Network Working Group  
Request for Comments: 175  
NIC 7074

Comments on "Socket Conventions Reconsidered"  
-----

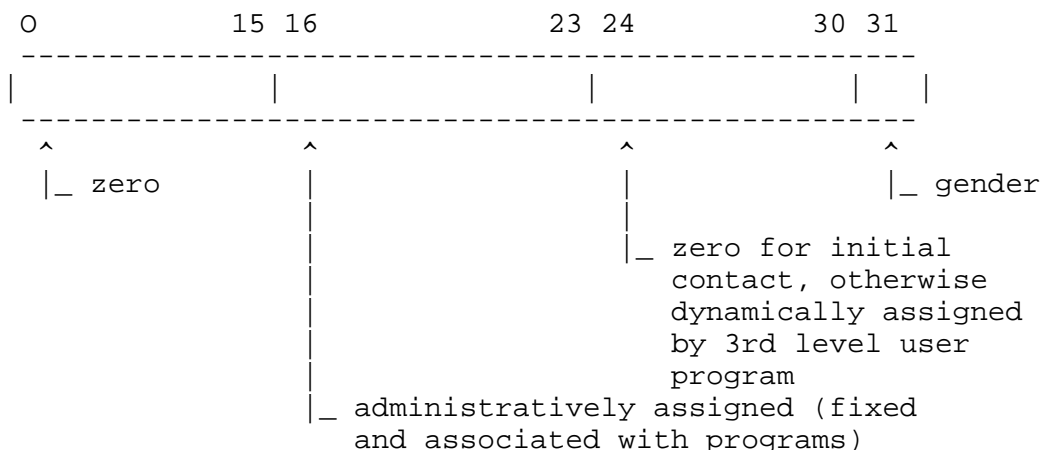
Our main departure in thinking from RFC #167 concerns the socket length. (See RFC #164, page 21.) Since there is an apparently serious TIP storage consideration, Rand- assigned sockets will have the high-order 16 bits zero.

For the particular programs (current and pending) that Rand must access, repeatability of socket name (RFC #167, page 3) is not necessary for the user process and also not necessary for the server process except for initial contact (ICP) sockets.

Our current use of socket names is diagrammed below.
